**TREGONING PROPERTY  
PRELIMINARY PLAN NO. 120230120 AND PRELIMINARY  
FOREST CONSERVATION PLAN NO. F20230420**

**Description**

Request to create forty-four (44) lots for single-family dwelling units, composed of thirty-eight (38) lots for single-family detached dwelling units and six (6) lots for townhouse dwelling units, including 12.5% MPDUs, with associated public streets, open spaces, and recreational amenities.

MCPB

Figure 11 – Explored Off-site Pedestrian Mitigation Options Overlaid on Pedestrian Level of Comfort Map

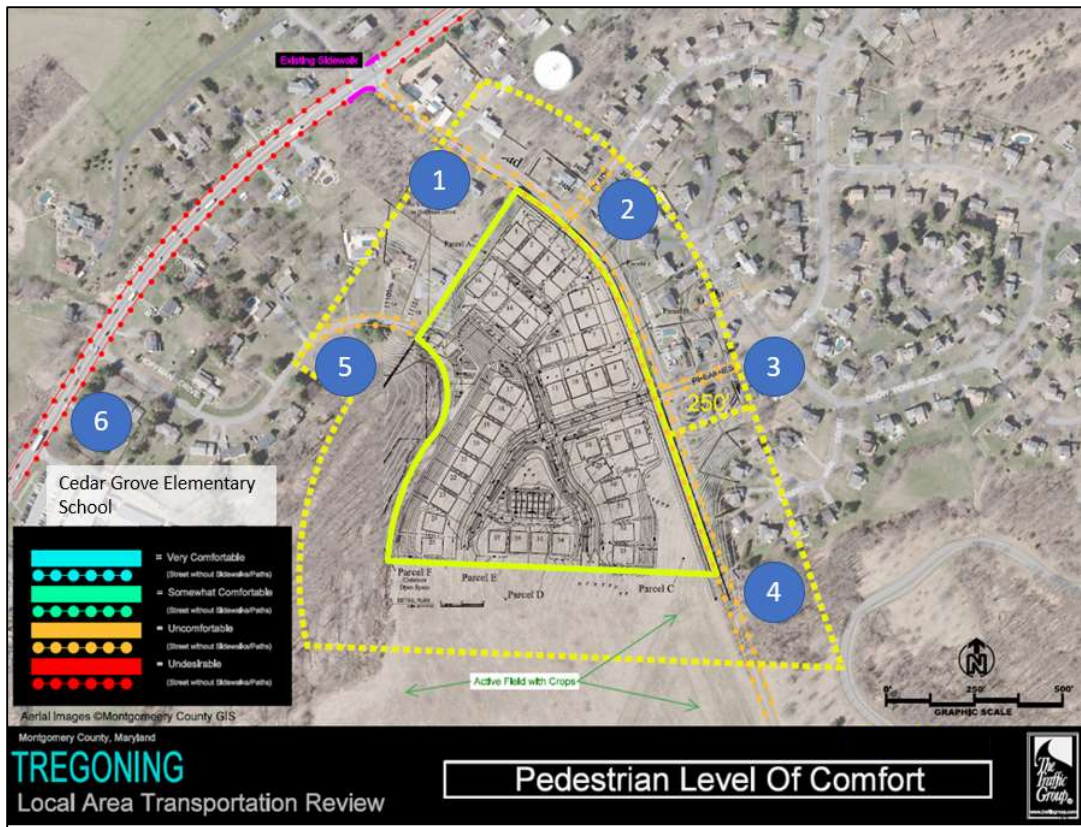
As the date of writing of the Staff report, the Applicant has not studied or provided options for required off-site mitigation. For expediency, Planning Staff has coordinated with SHA, MCDOT and MCDPS to explore an adequate option for off-site mitigation improvement. Six options were explored: (1) extending sidepath to the north on Kings Valley Road; (2) building sidewalk on Glade Valley terrace; (3) building sidewalk on Preakness Drive; (4) extending sidepath to the south on Kings Valley Road; (5) extending sidewalk on Hoffman Drive; and (6) extending sidewalk along Ridge Road to connect Cedar Grove Elementary School. The first five options outlined above are not preferred as they do not tie into a larger network, at best would provide connectivity to five to eight existing residences, which would therefore would not provide much value until additional connections are made in the future. Additionally, grade and limited ROW appear to limit the feasibility of implementation of these options.

In lieu of the first 5 options, Staff has conditioned option 6, the construction of approximately 360 feet of sidewalk along Ridge Road to connect Cedar Grove Elementary School to Hoffman Drive to the north (Figures 11 and 12).

Figure 15 – Forest Conservation Parcel 104

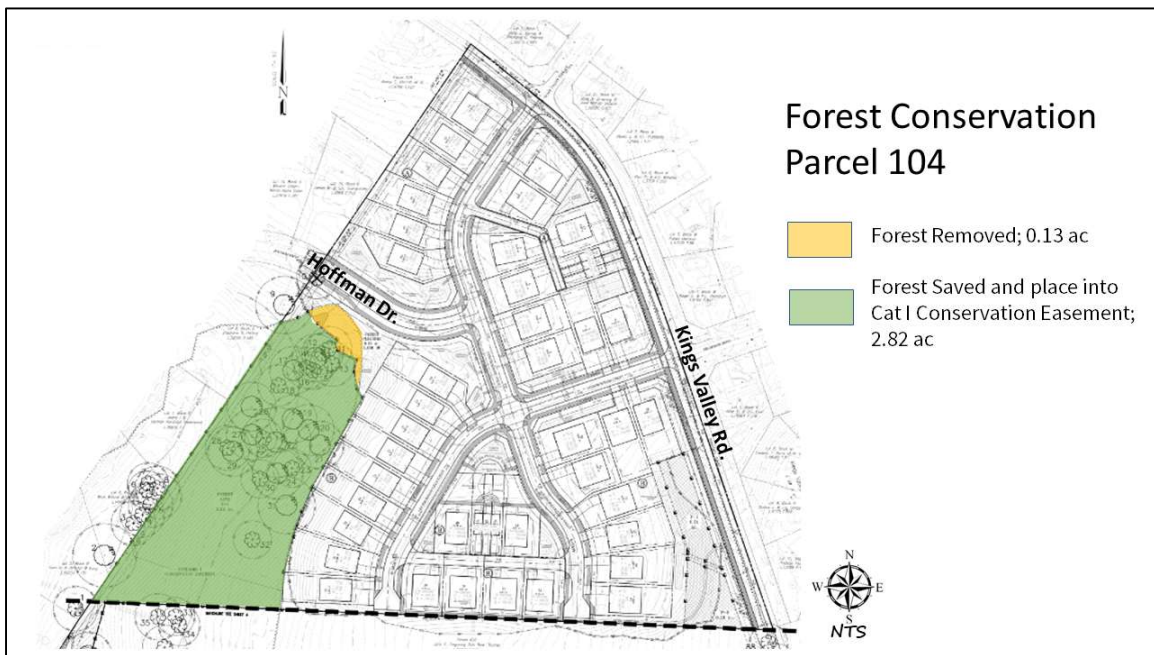
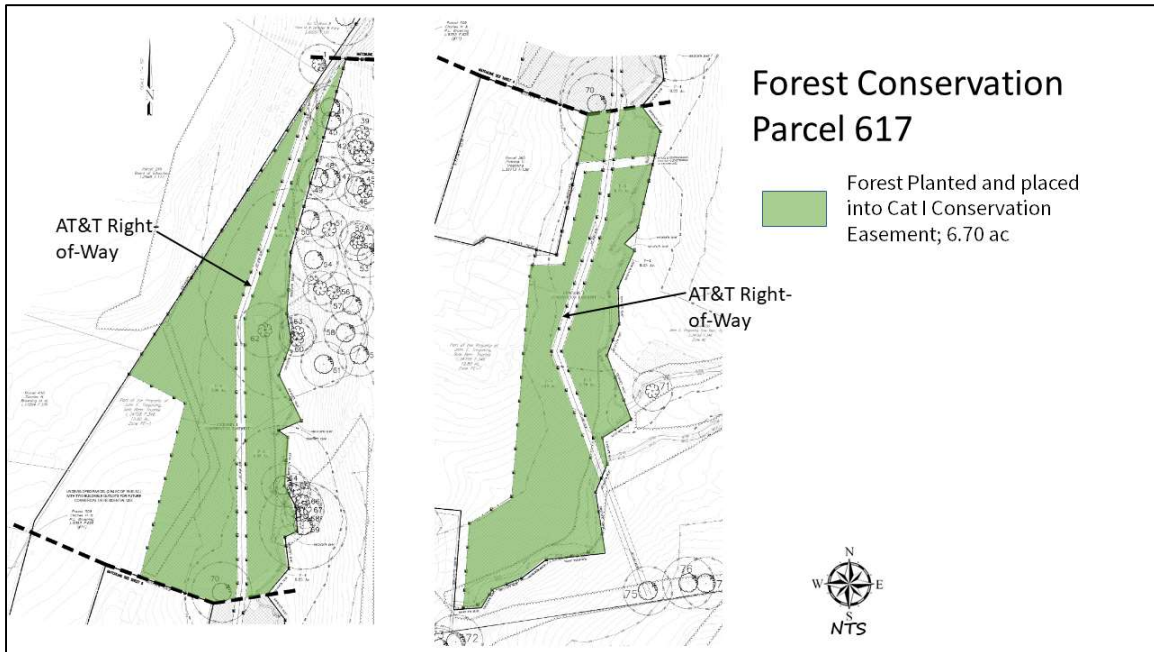
The Net Tract Area for forest conservation purposes includes the Total Tract Area plus 0.38 acres of offsite disturbance associated with this Application and minus 1.24 acres of land dedication for rights-of-way, for a total net tract area of 36.99 acres. There is a total of 2.95 acres of existing forest on the Subject Property with the Applicant proposing to remove 0.14 acres of forest. This results in a total afforestation/reforestation requirement of 4.57 acres within the same watershed/Priority Area or 4.64 acres outside of the same watershed/Priority Area. The Applicant proposes to meet the planting requirement by reforesting the 6.93 acres of unforested stream valley buffer as required under Sec. 22A-12(e)(1)(B) of the Forest Conservation Law (Figures 15 and 16).

Figure 17 – Proposed Conservation Easements to be Removed

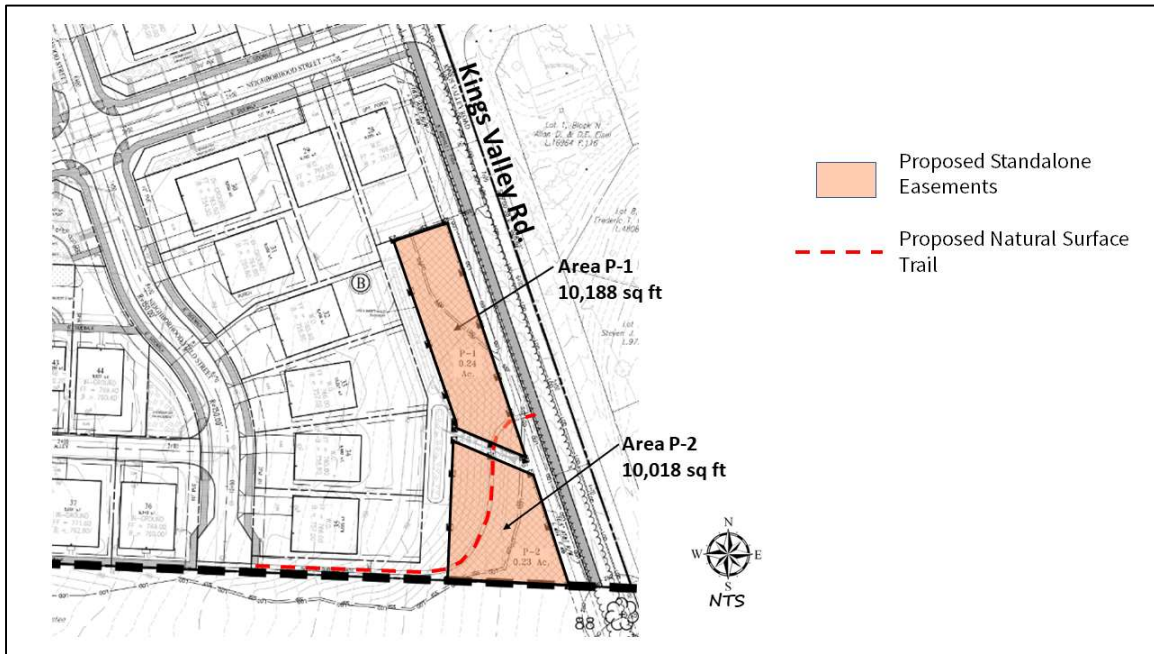
The Applicant has proposed to provide reforestation plantings within two small areas along Kings Valley Road, areas P-1 and P-2, and place these areas into Category I Conservation Easements (Figure 17). Each area is 50-ft wide and just over the minimum required area measurement of 10,000 square feet as specified under Sec. 22A.00.01.08.E(1) which states that afforestation and reforestation areas must be at least 10,000 square feet in size and 50-feet wide or be adjacent to a larger forest, either on-site or off-site, which is protected. These proposed areas would also be isolated standalone easement areas that are not adjacent to any larger forested areas. The Applicant is also proposing a 4-ft wide natural surface trail that leads from the nearby cul-de-sac, passes through reforestation areas P-1 and P-2, and connects to the proposed sidewalk along Kings Valley Drive.

As conditioned, reforestation areas P-1 and P-2 should not be placed into Category I Conservation Easements. Primarily, because these areas are not necessary for the Applicant to meet the reforestation requirement under the PFCP Worksheets. The Applicant’s reforestation requirement under the PFCP Worksheets is 4.71 acres. The Applicant is meeting this requirement by reforesting 6.93 acres of unforested stream valley buffer on Parcel 617. Reforestation Areas P-1 and P-2 are in excess of the reforestation requirement and as such do not require long term protection with Category I Conservation Easements. Secondly, Areas P-1 and P-2 are isolated, standalone areas that are not adjacent to existing Category I Conservation Easements or in environmentally sensitive areas such as

stream or wetlands. These small, isolated conservation easement areas have historically proven to be difficult to enforce with likely encroachments into the easements resulting in violations.

- e) Before Certified Preliminary Forest Conservation Plan approval, the Applicant must remove the Category I Conservation Easements over Reforestation Areas P-1 and P-2.

Figure 18 – Sewer Alignments

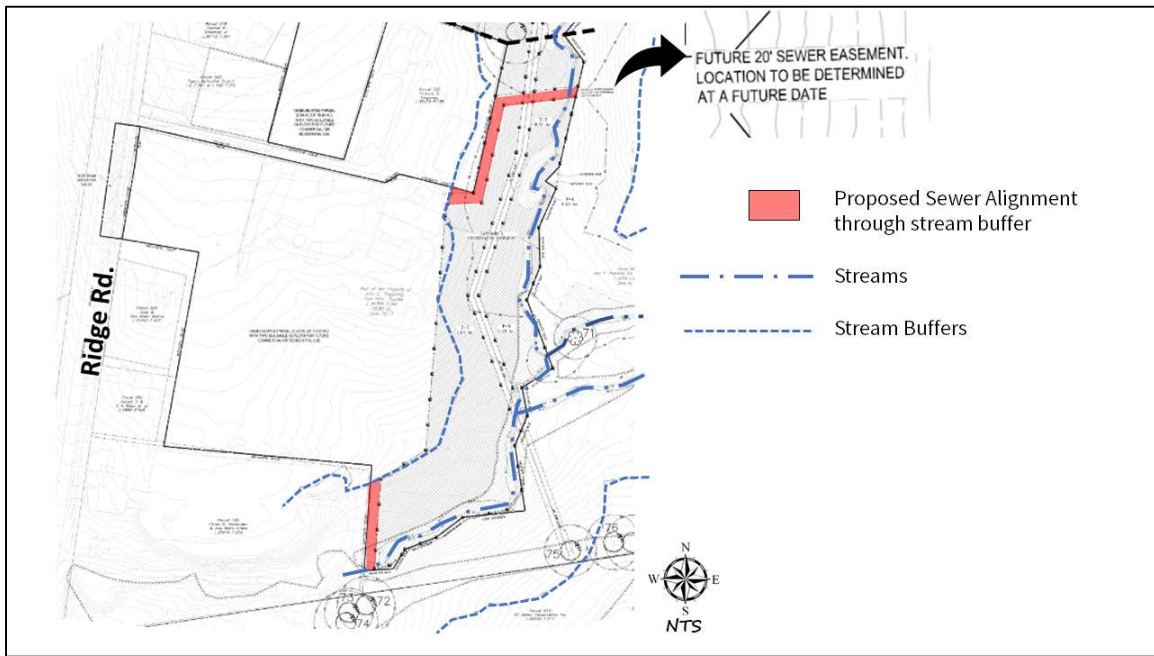
The Applicant is currently showing on the PFCP two 20-foot-wide possible sewer easements bisecting the stream and stream valley buffer on Parcel 617 (Figure 18). These areas are called out by note on the PFCP saying they are “Future 20’ sewer easement. Location to be determined at a future date.” Staff understands that these were placed on the PFCP in order to address the requirements under Montgomery County Resolution 18-1272 (Attachment K) dated October 30, 2018 addressing a Water and Sewer Category Change for Parcel 617. However, the Resolution does not set the sewer alignment as shown on the PFCP. The Resolution states “Maintain W-5 and S-5, with final approval of W-1 and S-3 conditioned on the Hearing Examiner’s approval of a conditional land use under the RE-1 Zone for the elder care facility.” In relation to the alignment, the Resolution states “The alignment and construction of the low-pressure sewer main for the elder-care facility project site, between the southwest corner of the site and the residential development at the northern end, will be evaluated through the development plan review. This alignment will need to minimize impacts to wooded areas and to streams and stream buffers, especially within proposed park dedication areas.”

To date, no development plans have been submitted for Parcel 617. This current Application involves Parcel 617 only to the extent that all but two density units associated with this parcel are being transferred to Parcel 104. In addition, the note on the PFCP implies that the location of the sewer alignment will change in the future once development plans are created for Parcel 617.

Showing the possible future sewer alignments on the PFCP is premature and that the true alignment can only be accurately determined once a Conditional Use application has been approved by the Hearing Examiner and a development plan is submitted for Parcel 617. Only at that time can the alignment be set, the impacts to the stream and stream valley buffer be analyzed and those impacts reduced as much as possible as required under Resolution 18-1272. As a result, Staff recommends that the 20-ft wide sewer easement alignments be removed from the PFCP and to be shown on the future development plan for Parcel 617.

- d) Before Certified Preliminary Forest Conservation Plan approval, the Applicant must remove the proposed 20-foot-wide sewer line easements through the stream valley buffer shown on the PFCP on Parcel 617 and record a Category I Conservation Easement over the entirety of the stream valley buffer exclusive of the AT&T right-of-way. At the time that a development application is submitted for Parcel 617, the sewer line alignment will be determined with minimal disturbance to the stream buffer or associated forest.

Figure 19 – Variance Trees

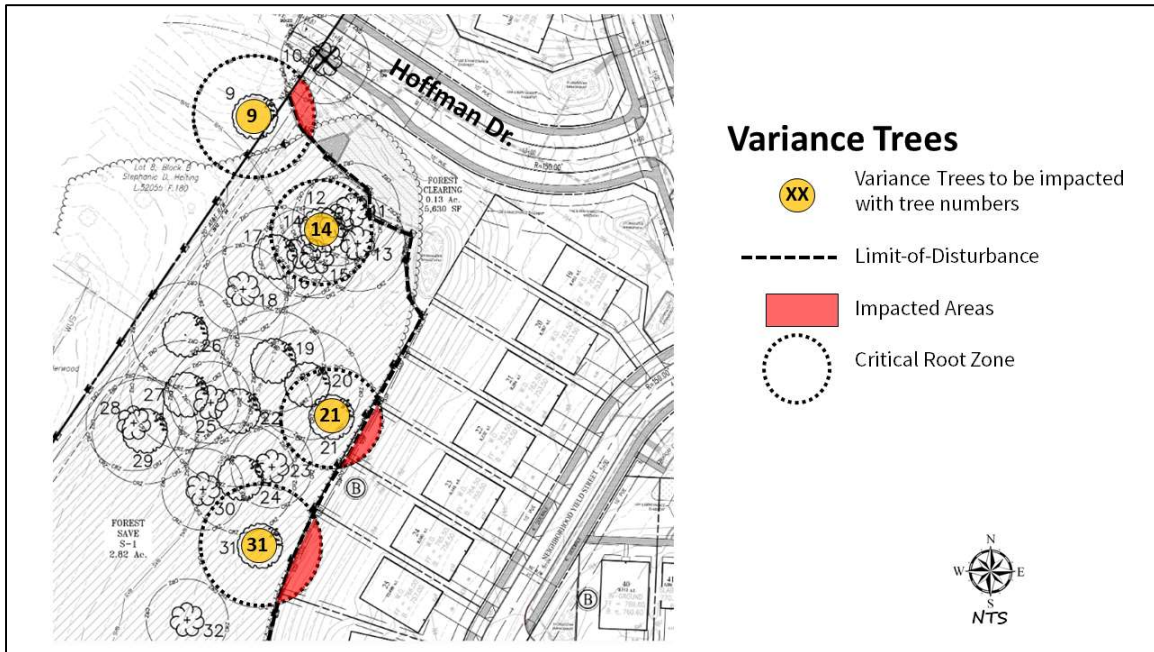
The 4 Protected Trees proposed to be impacted are located in close proximity to the LOD of the development (Figure 19). Three of these trees are within, but near the perimeter, of the existing forest cover on Parcel 104. The fourth tree, Tree 9, is located off-site on an adjacent property, but near Hoffman Drive. Trees 9 and 14 will be impacted by the necessary site grading for the installation of Hoffman Drive on the Subject Property. Trees 21 and 31 are located near the perimeter of the existing forest cover and will be impacted by the LOD for site grading for 5 residential lots, Lots 22-26 of Block B.

The inability to impact these 4 Protected Trees would prevent the installation of Hoffman Drive thereby denying necessary access to the site that is required by Montgomery County. It would also likely prevent the development of Lots 23-25 and impact the development of Lots 22 and 26 by limiting the area for site grading to create level pad areas for these lots. As a result, this would deny access to the site and would render portions of the site undevelopable. Therefore, there is a sufficient unwarranted hardship to justify a variance request because the Applicant would otherwise be denied the ability to use the entirety of the Property for the development of single-family homes allowed under the RE-1 zone, which is a reasonable and significant use of the Property.
